2004 ADD. 20 75

ADA Compliance for Emergency Telephones at Various Locations on Oahu Federal Aid Project No. CMAQ-0300(100)

10/18/04 REVISED DETAILS DATE

DEPARTMENT OF TRANSPORTATION TYPICAL CALL BOX INSTALLATION

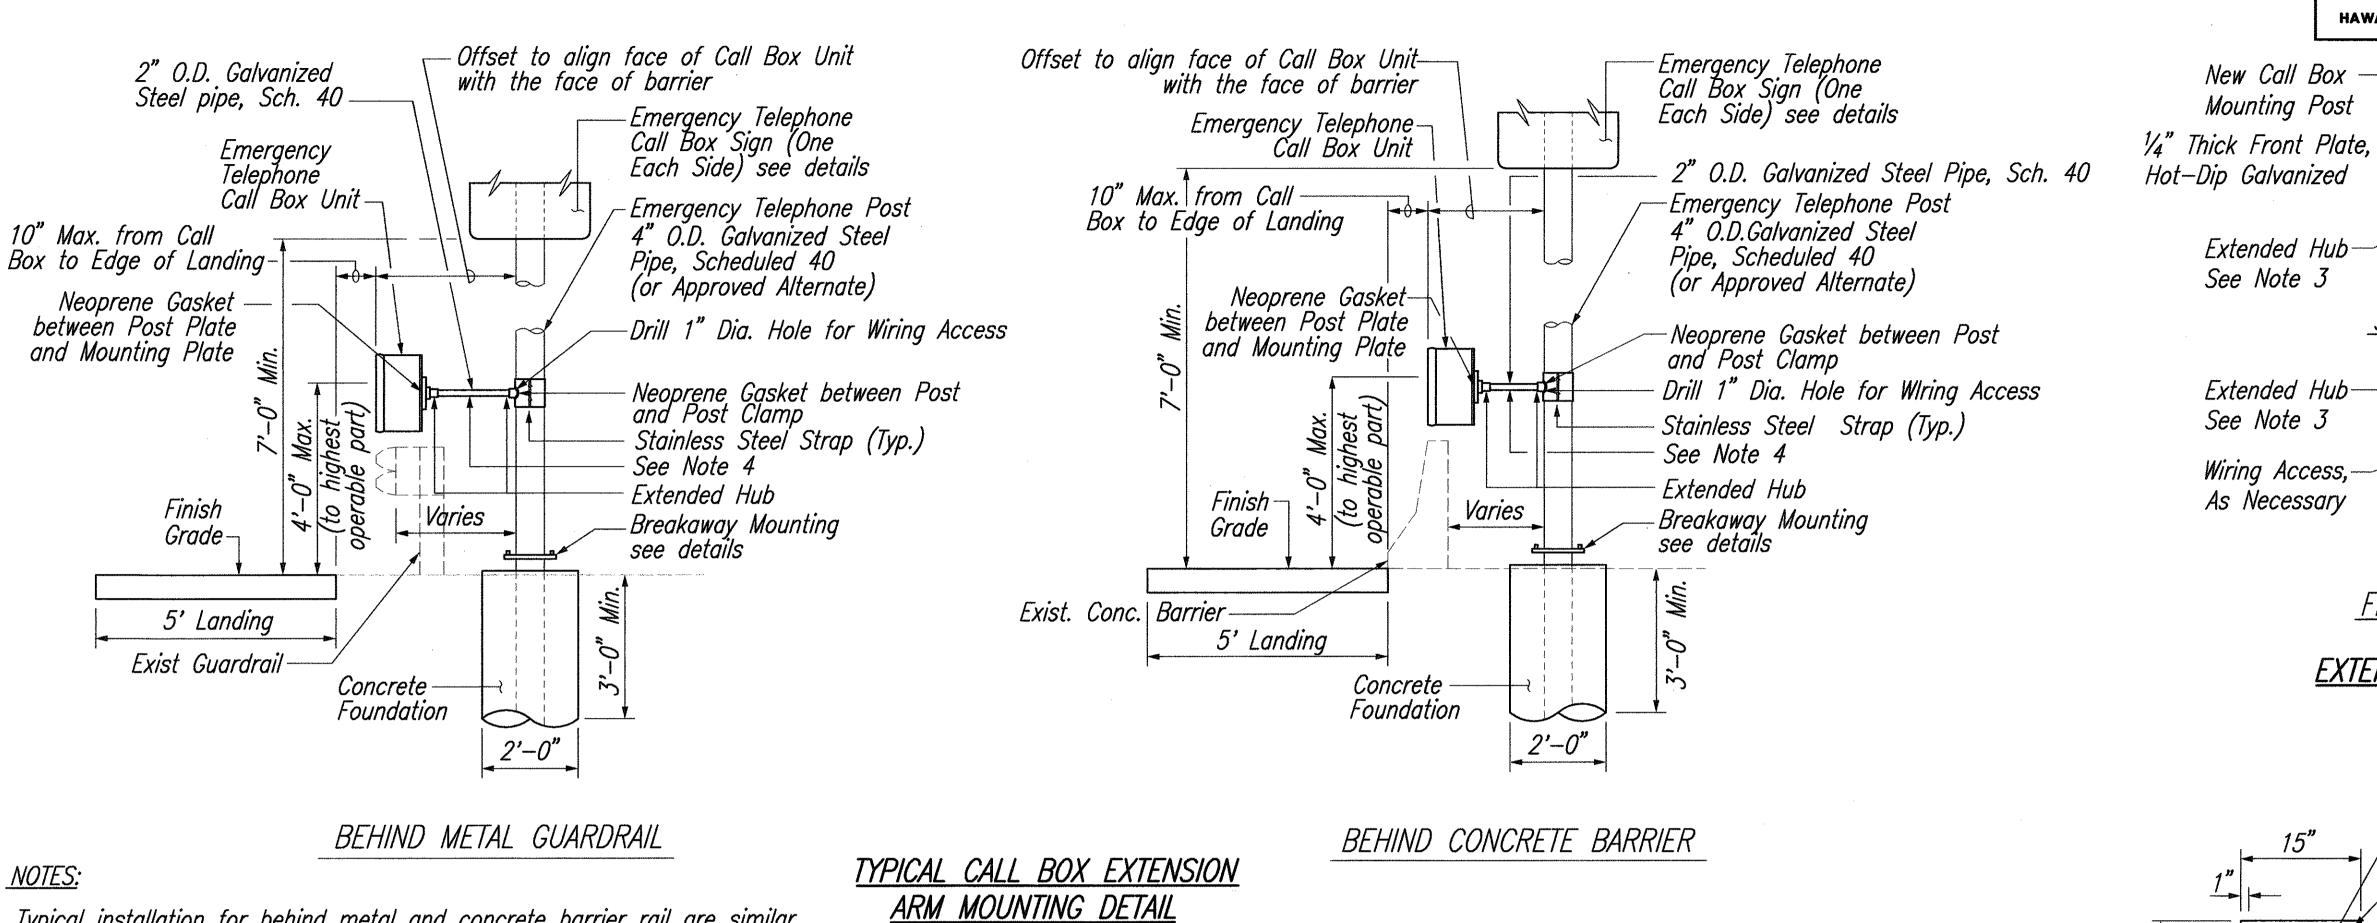
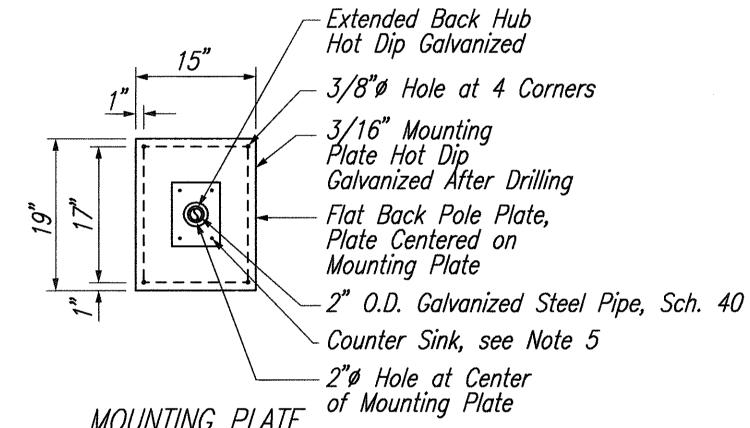
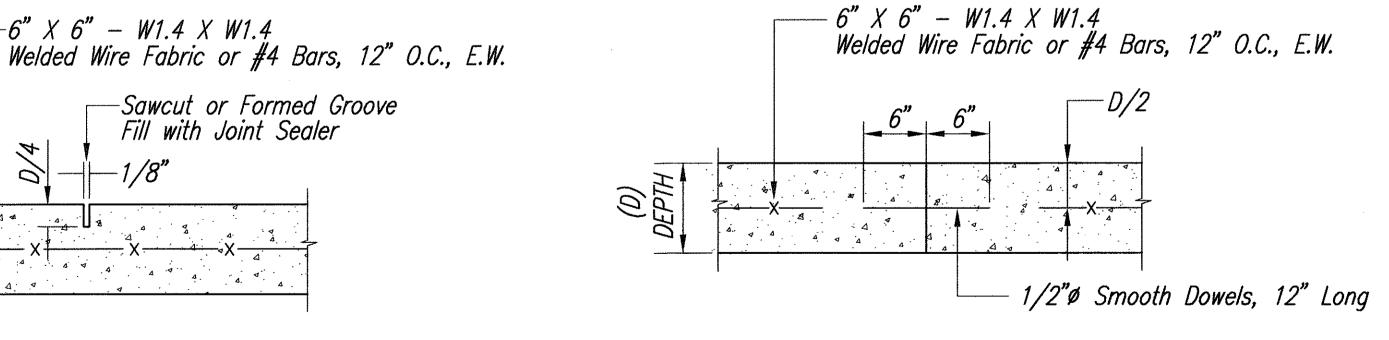
IN CHAPTER 16-115, HAWAII ADMINISTRATIVE RULES ENTITLED "PROFESSIONAL ENGINEERS, NEW PAVEMENT STRUCTURE (TRAVELWAY/SHOULDER) SCALE 1/2"=1'-0" & MISCELLANEOUS DETAILS 10/18/04 REVISED DETAILS

SHEET No. CB23 OF 74 SHEETS ADD. 24

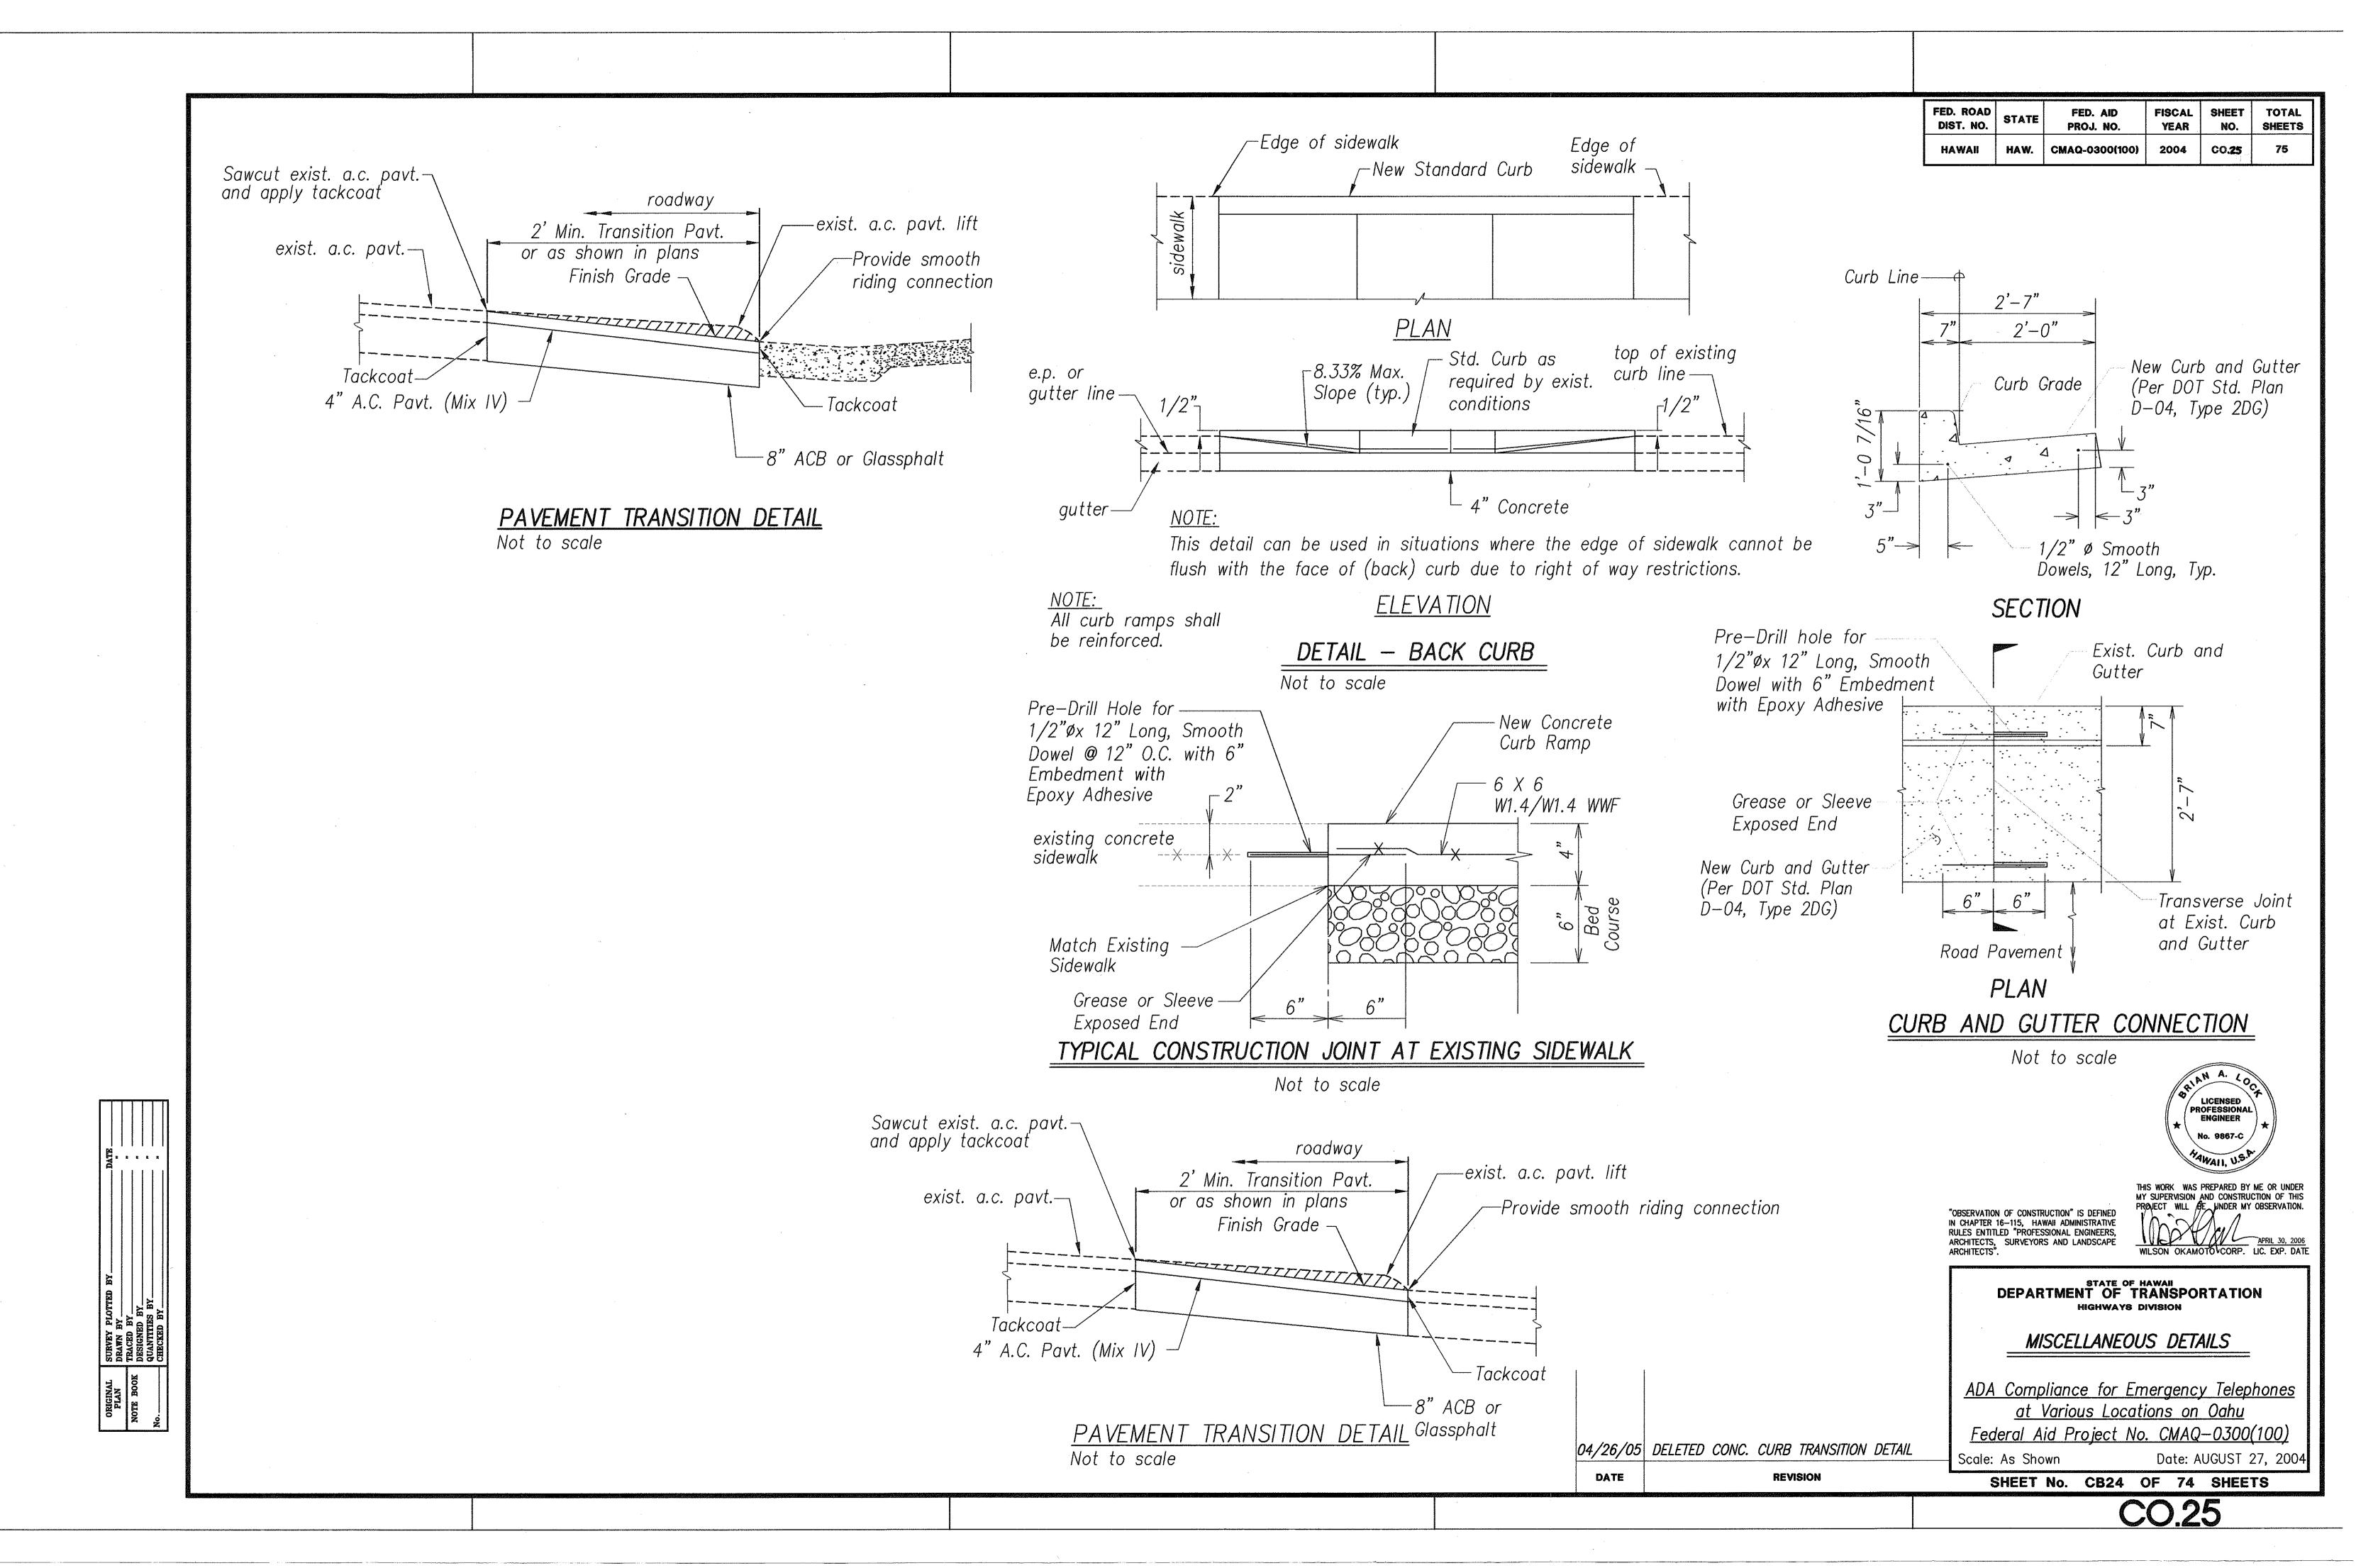
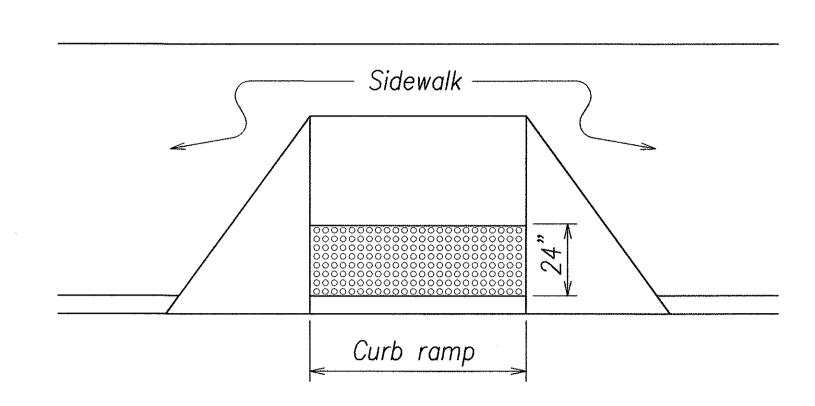
10/18/2004 ADDED ELECTRICAL DETAIL
